April 16, 2021

ADDENDUM NO. 3
TO CONTRACT DOCUMENTS FOR THE
PIEDMONT CREEK INTERIM CONCRETE REPAIR PROJECT
Project No. 62084001, Task No. 5230 Contract No. C0669

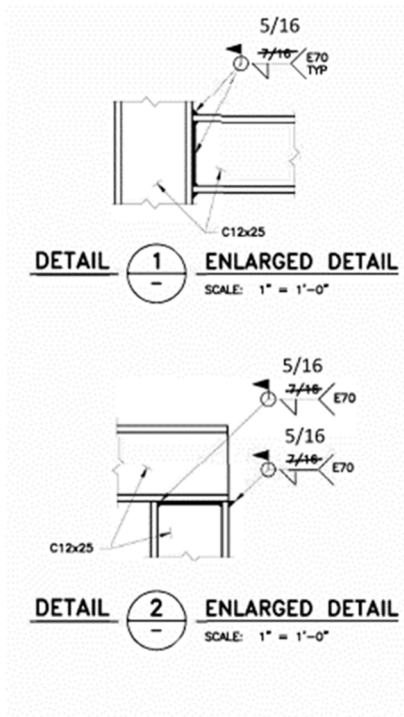
The response that the structural steel is not shop fabricated or modular per response #7 & #8 and various comments regarding an A Frame element is understood. But your detail for field welding cannot be achieved as marked on the plans.

The symbol required to attached members cannot be welded on all sides if the vertical member is attached to the wall and the other horizontal elements are welded to it. Please confirm that this is not required to WELD-ALL AROUND, just the exposed edges.

Welding for HSS struts to steel channel members will require WELD-ALL-AROUND, as shown in Plan Sheet S-01, Section A and Section B. However, for welding steel channels together, all exposed steel member connections outside the existing concrete wall surfaces shall be welded.

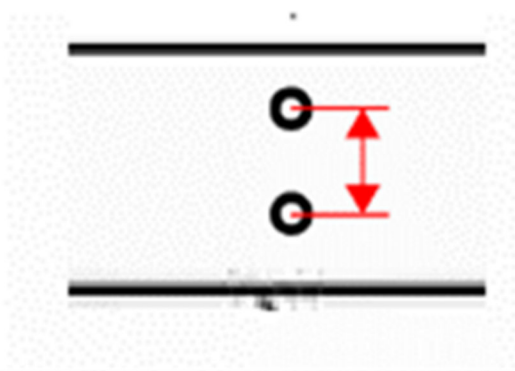
What is the tightening torque for the anchors to attach the channels to the wall?

Tightening of the torque depends on the manufacturer's recommendation for reaching the bond strength of the installed epoxy anchor.
